<b>Well Name:</b> BIG EDDY UNIT 30E SKYWALKER	<b>Well Location:</b> T20S / R31E / SEC 14 / NWSW / 32.570286 / -103.846945	<b>County or Parish/State:</b> EDDY / NM
<b>Well Number:</b> 100H	<b>Type of Well:</b> OIL WELL	<b>Allottee or Tribe Name:</b>
<b>Lease Number:</b> NMLC0063667, NMLC063667	<b>Unit or CA Name:</b> BIG EDDY	<b>Unit or CA Number:</b> NMNM68294X
<b>US Well Number:</b> 3001546194	<b>Well Status:</b> Approved Application for Permit to Drill	<b>Operator:</b> XTO PERMIAN OPERATING LLC

**Type of Submission:** Notice of Intent                      **Type of Action:** APD Change

**Procedure Description:** \*\*Casing & Cement Changes XTO Permian Operating, LLC requests permission to make the following changes to the original APD: Casing and cement changes due to US supply chain issues. Updated drilling program is attached. Attachments: Drilling Program MBS Diagram

## PECOS DISTRICT DRILLING CONDITIONS OF APPROVAL

<b>CACTUS WELLHEAD LLC</b>  20" x 9-5/8" x 7-5/8" x 5-1/2" MBU-T-CFL-R-DBLO Wellhead With 11" 10M x 7-1/16" 15M CTH-DBLHPS Tubing Head And 9-5/8", 7-5/8" & 5-1/2" Pin Bottom Mandrel Casing Hangers	<b>XTO ENERGY INC</b> <b>ICARUS PAD</b>		
	DRAWN	DLE	18JAN21
	APPRV		
	DRAWING NO. <b>HBE0000479</b>

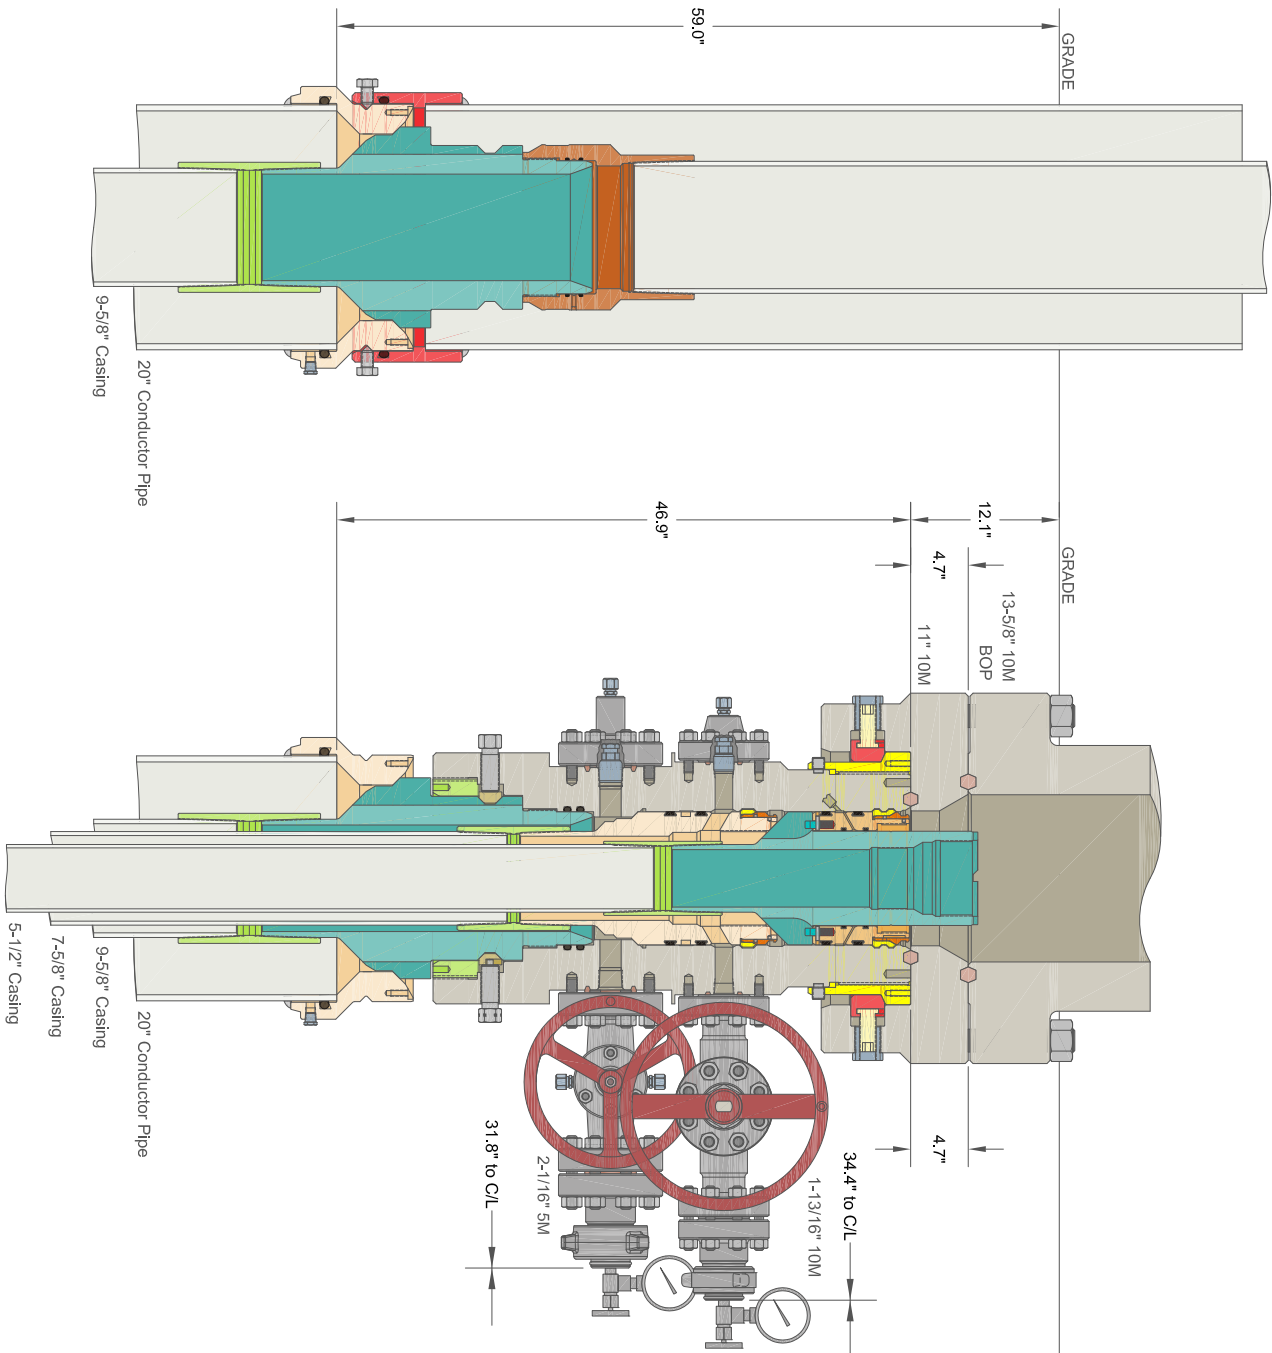
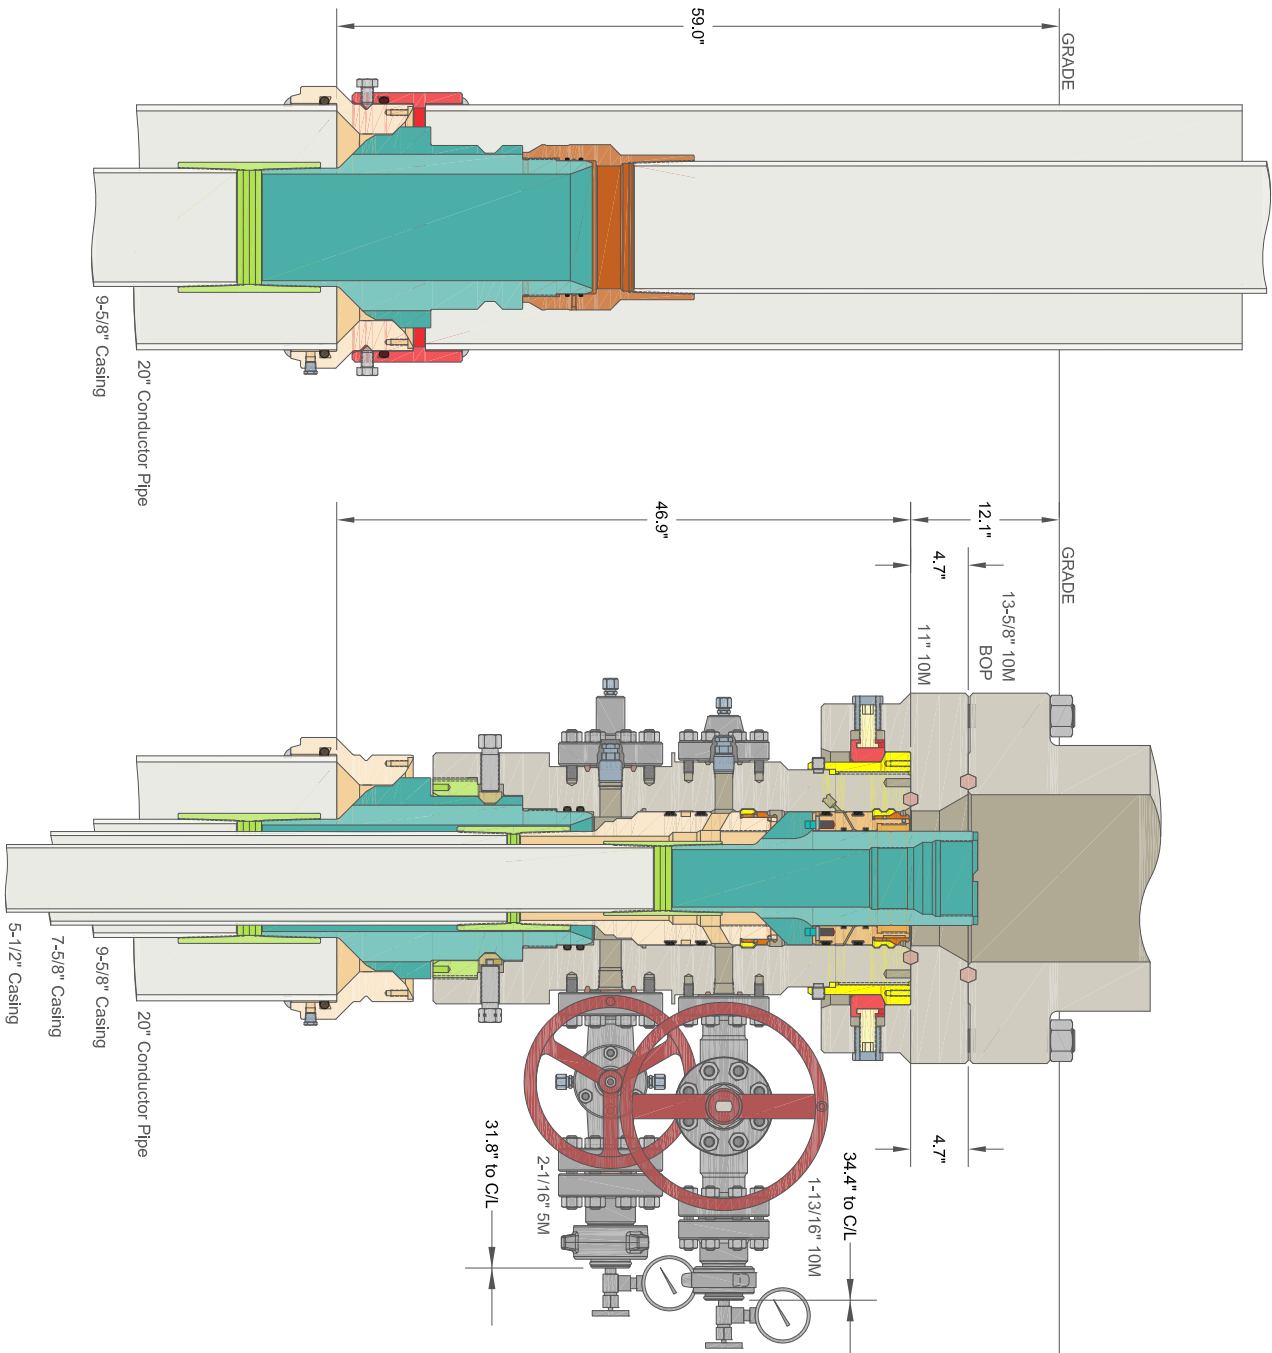
**Permanent Wellhead – Multibowl System**

A. Starting Head: 13-5/8" 10M top flange x 13-3/8" bottom

B. Tubing Head: 13-5/8" 10M bottom flange x 7-1/16" 15M top flange

- Wellhead will be installed by manufacturer's representatives.
- Manufacturer will monitor welding process to ensure appropriate temperature of seal.
- Operator will test the 9-5/8" casing per BLM Onshore Order 2
- Wellhead Manufacturer representative will not be present for BOP test plug installation

1. Variance approved to use flex line from BOP to choke manifold. Manufacturer's specification to be readily available. No external damage to flex line. Flex line to be installed as straight as possible (no hard bends).'
2. Operator has proposed a multi-bowl wellhead assembly. This assembly will only be tested when installed on the surface casing. Minimum working pressure of the blowout preventer (BOP) and related equipment (BOPE) required for drilling below the surface casing shoe shall be **2000 (2M) psi**.
  - a. Wellhead shall be installed by manufacturer's representatives, submit documentation with subsequent sundry.

- b. If the welding is performed by a third party, the manufacturer's representative shall monitor the temperature to verify that it does not exceed the maximum temperature of the seal.
- c. Manufacturer representative shall install the test plug for the initial BOP test.
- d. If the cement does not circulate and one inch operations would have been possible with a standard wellhead, the well head shall be cut off, cementing operations performed and another wellhead installed.
- e. Whenever any seal subject to test pressure is broken, all the tests in OOGO2.III.A.2.i must be followed.
